Site Plan and Design Review Staff Report and Recommendation

LAND USE REQUEST: Site plan approval and design review of a proposed 10-unit apartment building

FILE NUMBERS: 311-20-000108-PLNG & 311-18-000035-PLNG

PROPERTY LOCATION: 2838 19th Avenue

Proposed Site Plan

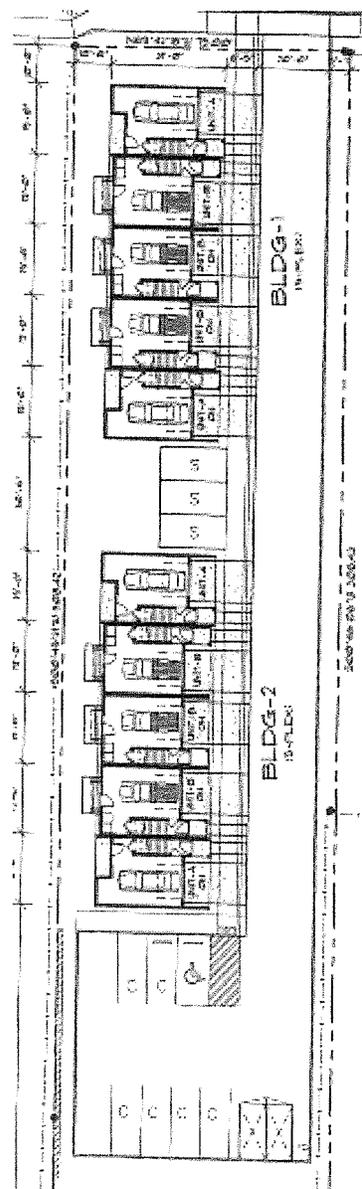
1. Description of Proposal: The proposal would result in the construction of 10 apartment units in 2 buildings. All would be 3-bedroom units. Each unit would have a single-car garage. There would be 11 surface parking stalls, for a total of 21 on-site spaces. The site would be completely built-out with this project.

The buildings would be sited on the west side of the property, due to the location of a public utility easement along the east property line that must remain open and accessible. Surface parking and the trash enclosure would be located at the south end of the site; additional surface parking would be provided between the buildings.

A walkway would run parallel to the building and would connect the car park with all the units and the 19th Avenue sidewalk. Each unit would have a patio and a deck.

7. Traffic and Circulation: The site would be served by a single driveway, taking access from 19th Avenue. DC §17.8.120(C) regulates minimum driveway width for multi-family dwellings; for two-way traffic the minimum width required is 20 feet. The proposed driveway would be 20 feet wide, in compliance with the requirement.

There are 21 parking spaces proposed on-site: 10 single-car garages and 11 surface stalls (including one ADA accessible space). With 75 feet of frontage onto 19th Avenue, less the 20-foot-wide driveway area, 2 on-street spaces would also be available adjacent to the site. DC §17.8.510(H) states that "Parking spaces available along the public street frontage or alleys are eligible in fulfilling parking requirements, except for single family dwellings and duplexes." Including the on-street spaces, 23 parking stalls would be available overall, which would exceed the minimum number of spaces required.

FRONT EXTERIOR ELEVATION (BUILDINGS 1 & 2)

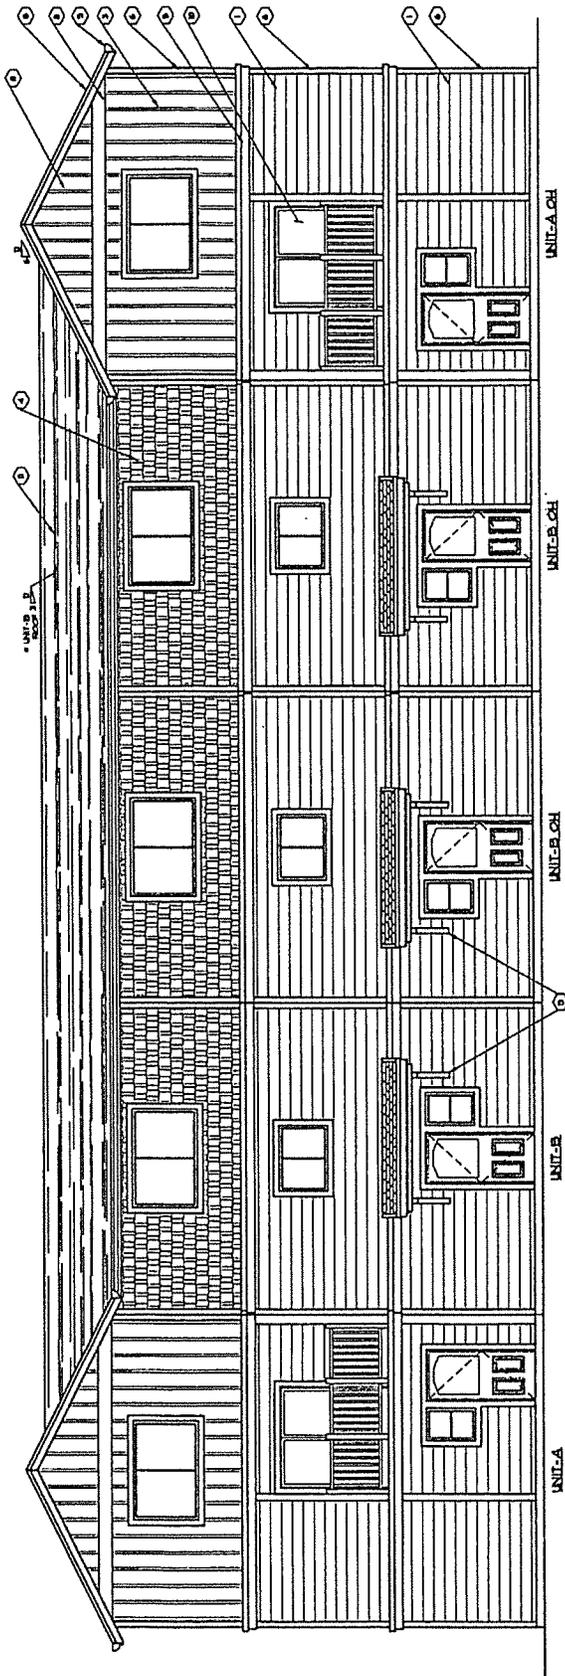
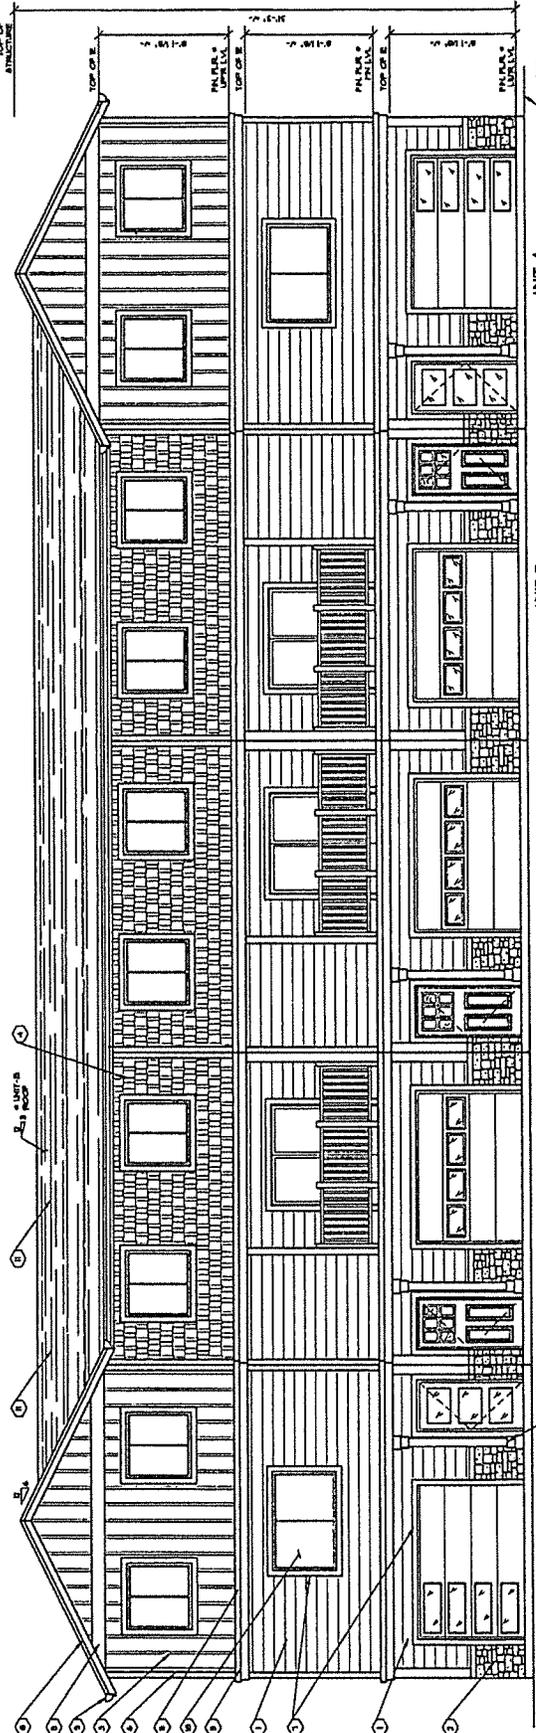
Each building would be 3 stories tall. They would have lap siding on floors 1 and 2, while the 3rd floor would have shake siding on the interior units, and board and batten siding on the end units. The interior unit garage doors would have a row of windows

while the end-unit garages would have windows in a column. Front doors would be similarly differentiated. Windows would be installed in the front and rear (east and west) elevations, but no windows are proposed for the north or south elevations. The front (east) façade would be enhanced with architectural columns and masonry wainscoting.

Finding: The height limit in the CC zone district is 45 feet. The height of the proposed apartment building would be about 31 feet 3 inches at the roof peak.

1. All habitable rooms facing a car park or 19th Avenue shall have a window.
